May 2, 2023,  
Via Electronic Filing

Re: Docket LC 80: Comments on Portland General Electric's Clean Energy Plan and Integrated Resource Plan

**Figure 77. Net cost of a microgrid CBRE (2026 COD)**

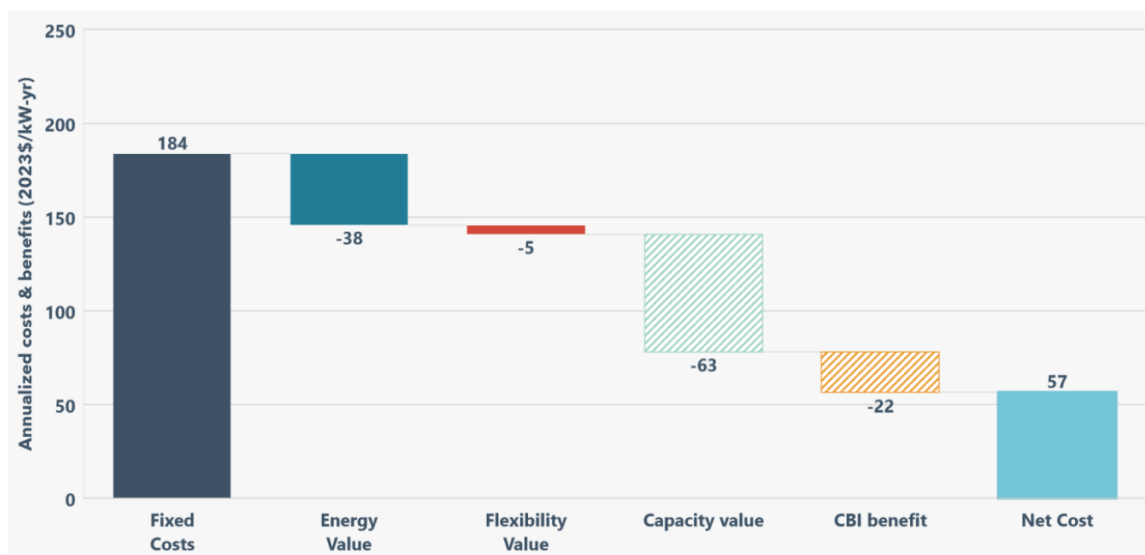
This chapter describes how the overall economics of various resource options are assessed, including fixed investment and operating costs, variable operating costs, flexibility value and integration costs, load carrying capacity and capacity value to determine a net cost for all resource options. For the final component, the Resource Community Benefits Indicator (rCBIs), PGE created a CBRE resource within the construct of its resource portfolio that reduces the fixed cost of the proxy resources evaluated by 10 percent as shown below, where it appears that the CBI benefit of 22 = 0.1\*(184+28), or 10% of the fixed cost and the energy value). *Is this interpretation correct?*
